# EDINBURG CISD

## ADDENDUM 2

CSP 22-70

### Edinburg High School Heating & Air Condition (HVAC) Improvements Funded through the Elementary & Secondary Emergency Relief (ESSER) Funds April 6, 2022

**1 ELECTRICAL POWER PLAN - AREA H MEZZANINE**  
EP2.14 1/8" = 1'-0"

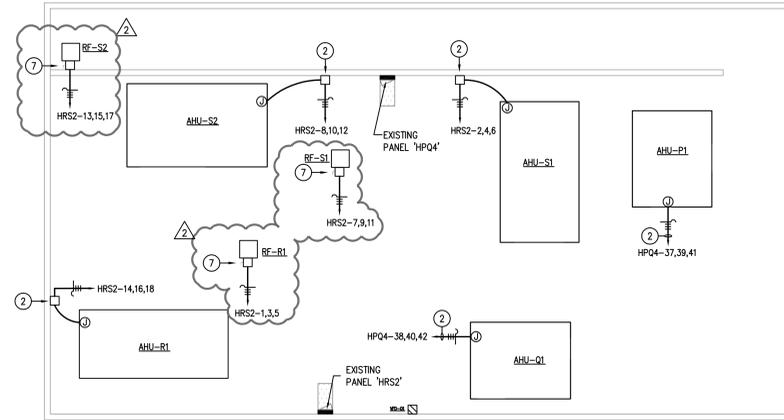
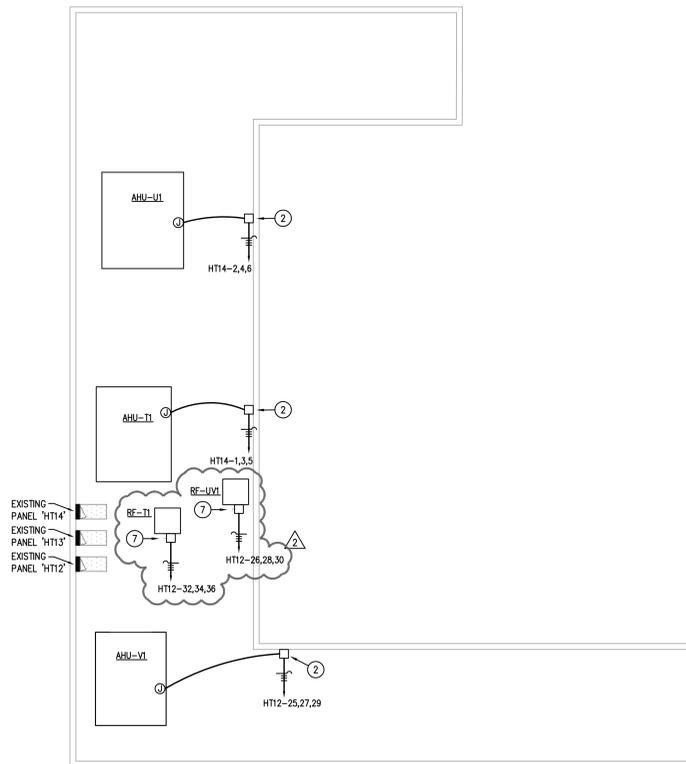
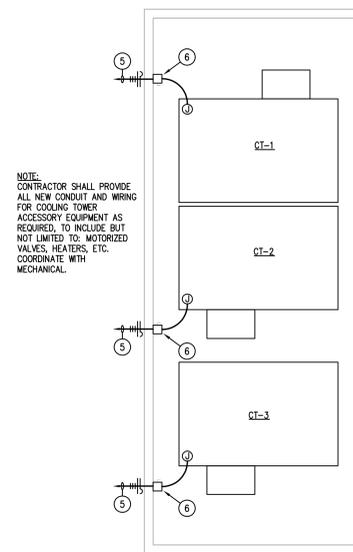
1. Add power for additional RF fans.
2. Add keyed note #7
3. Add circuit requirements for additional RF fans to Electrical Schedule.
